FALCON SERVICE BULLETIN

FALCON 8X

No 600

**GENERAL
ENHANCED AVIONICS SYSTEM
EASY IV**

Figure 1: AGM BACKSHELL

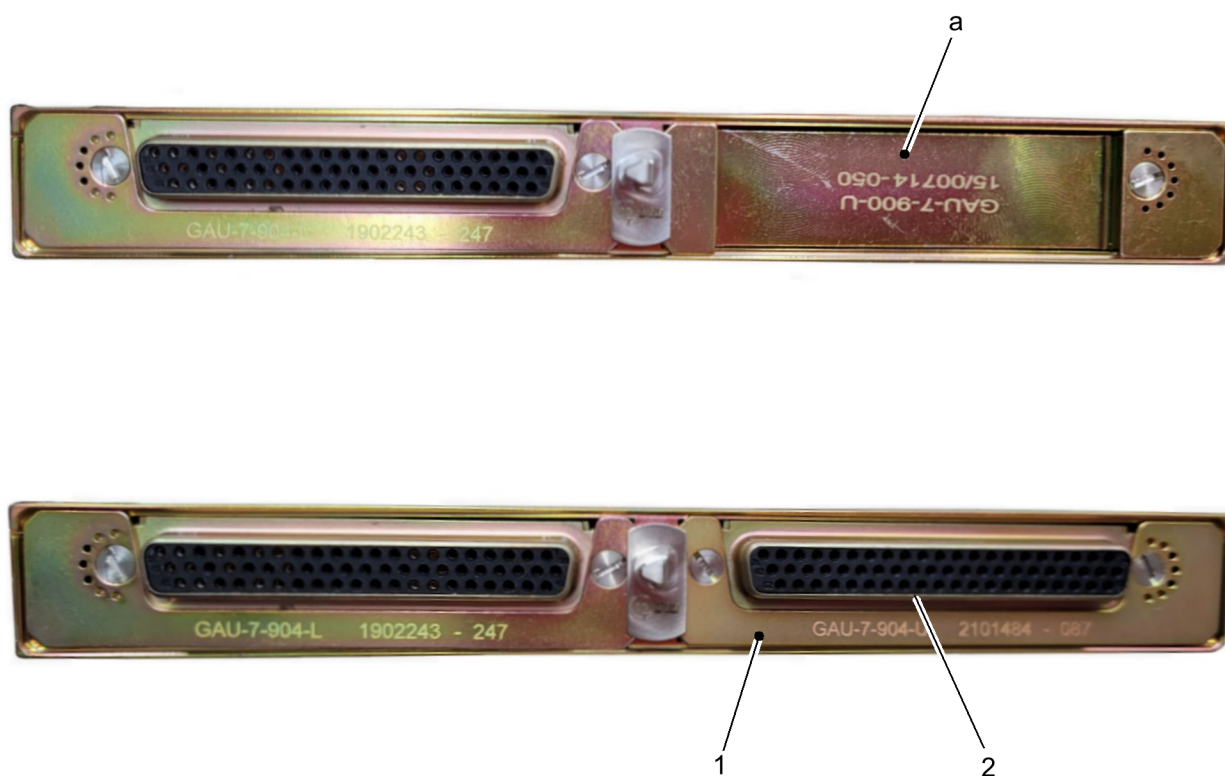
- (1) Perform the following modification on each AGM backshell 1:
 - (a) Fill the new connector (**2-fig. 1**) with blanking pins.
NOTE: This new connector has no wire connected to it.
 - (b) Open the backshell 1.

- (c) Remove the blank backplate (**a-fig. 1**).
- (d) Install the connector backplate (**1-fig. 1**) and the connector (**2-fig. 1**).
- (e) Close the backshell 1.

Figure 2: WDM 34-23-50 - TERRAIN SERVER BUS WIRING MODIFICATION

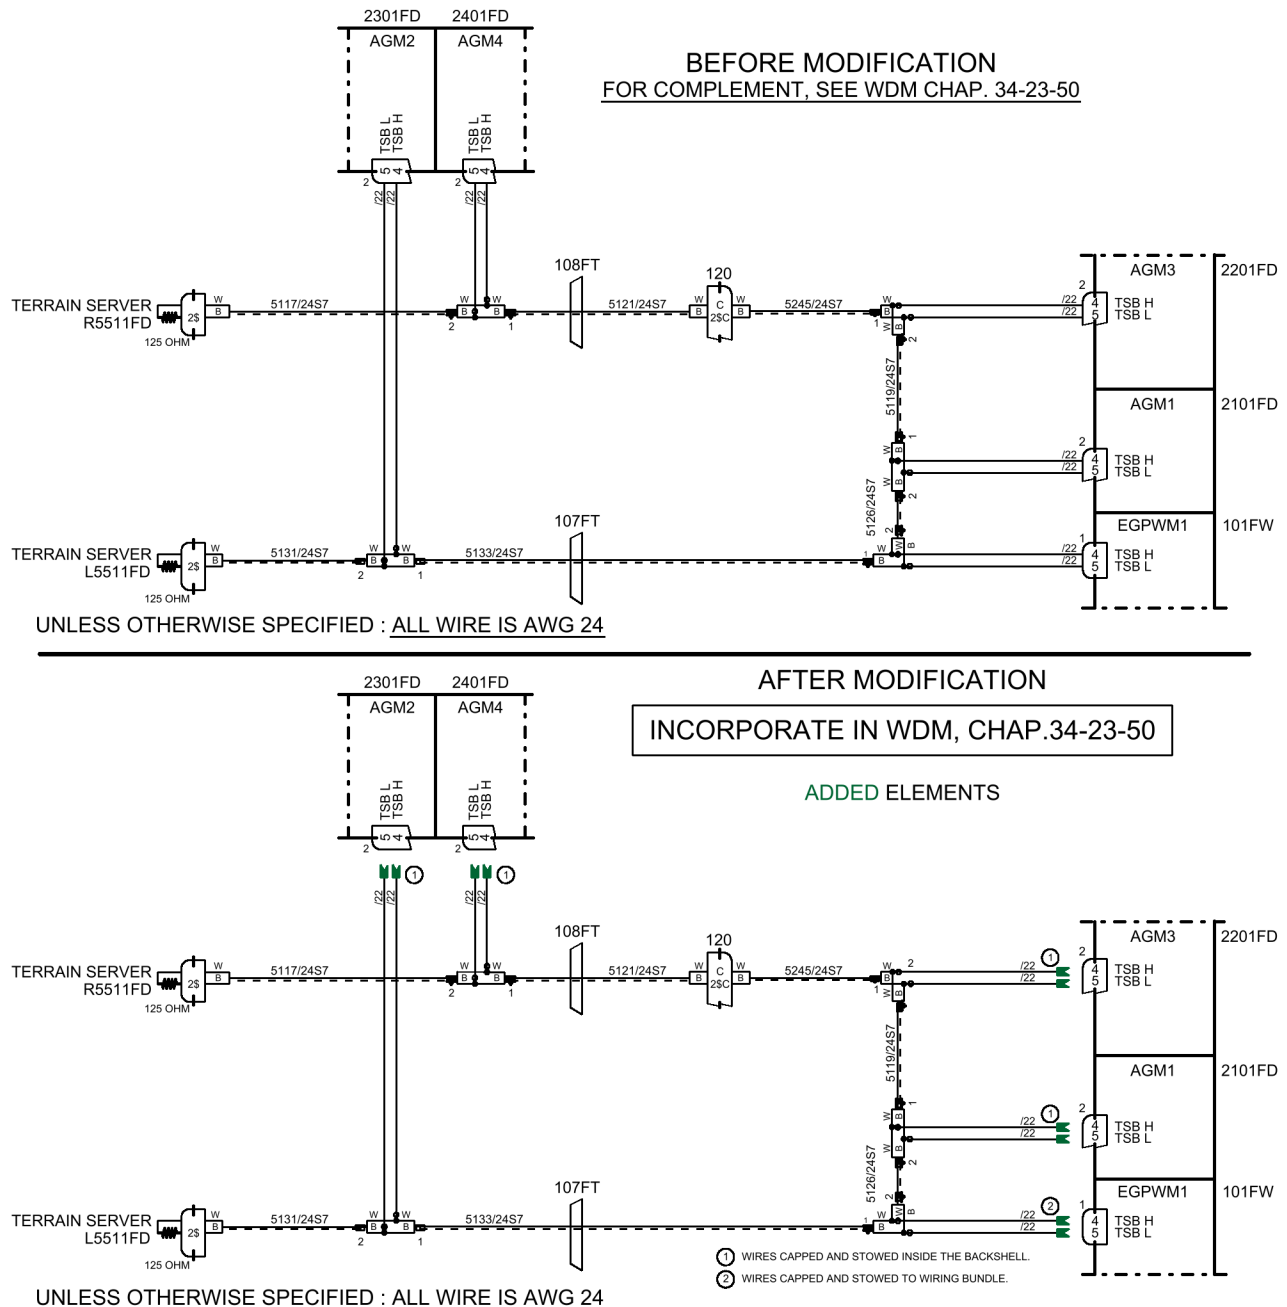
- (2) Perform the following modification on each AGM backshell 2:
 - (a) Open the backshell 2.
 - (b) Disconnect the two wires from the backshell as per wiring diagram (**item 1-fig. 2**)

- (c) Cap and stow the two wires inside the backshell.
 - (d) Close the backshell 2.
- (3) Perform the following modification on the backshell of the EGPWS 1 module (**101FW**):

- (a) Open the backshell.
 - (b) Disconnect the two wires from the backshell as per wiring diagram (**item 2-fig. 2**).
 - (c) Cap and stow the two wires to wiring bundle under the cabin floor.

Incorporate Airplane Flight Manual revision 6 or subsequent revision pages.
Incorporate **fig. 2** in Wiring Diagram Manual chapter 34-23-50.
Incorporate **fig. 3** and **fig. 4** in Wiring Diagram Manual chapters 34-40-00 and 34-45-00.

Figure 4: WDM 34-40-00 & 34-45-00 - AFTER WIRING MODIFICATION

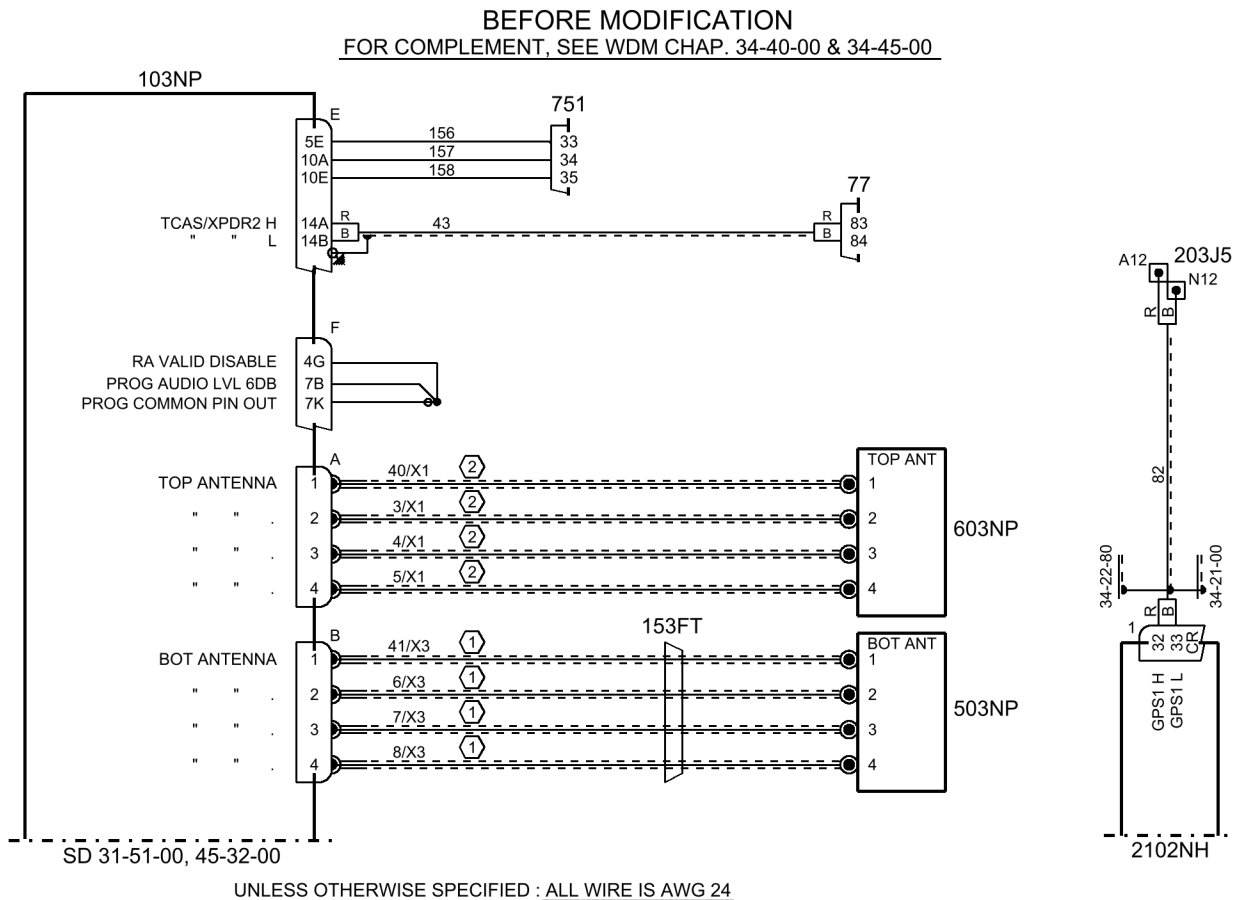
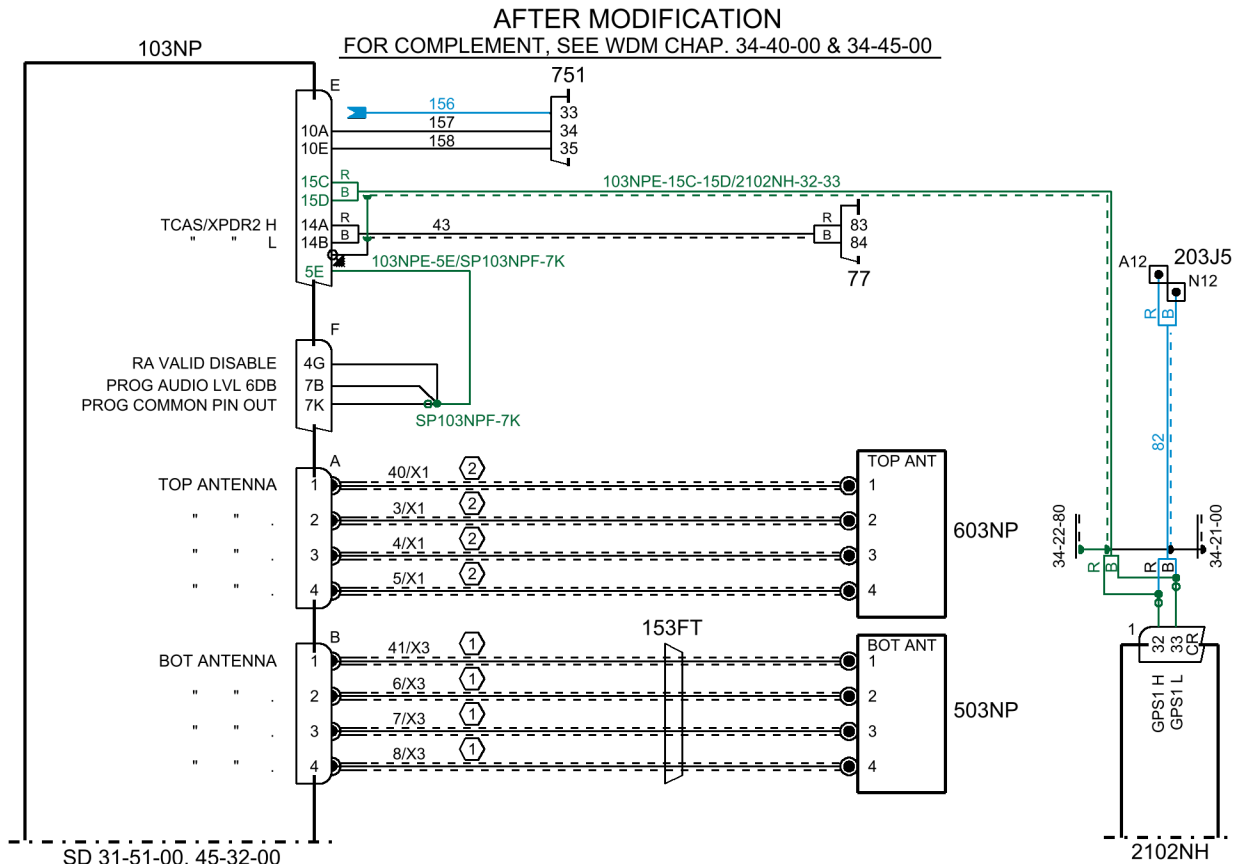
- (d) Discard the backshell.
- (4) Perform the electrical modification as per wiring diagrams **fig. 3** and **fig. 4**.
- (5) Perform an electrical continuity check of the aircraft wiring.

INCORPORATE IN WDM, CHAP.34-40-00 & 34-45-00

Figure 1. RP-1 Radar Processor, Front View

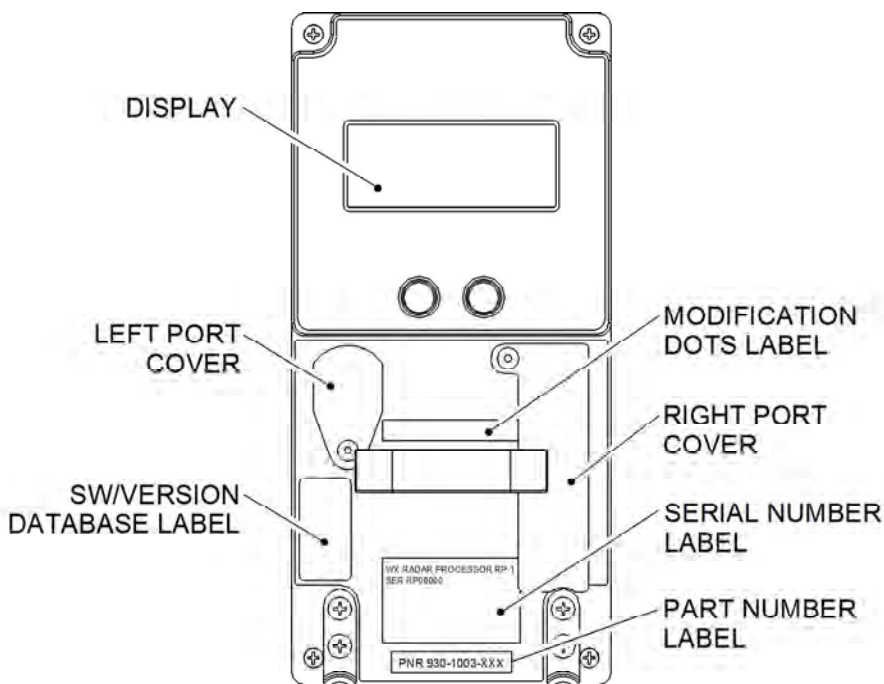
- 1 Make sure the RDR-4000 is not transmitting by verifying the radar is in "Standby".
- 2 Make sure no power is applied to the RP. Put the configuration feature software CF card, PN 718-1761-020, in the vertical slot under the right port cover. The right port cover is on the front panel of the RP. Refer to [Figure 1](#).
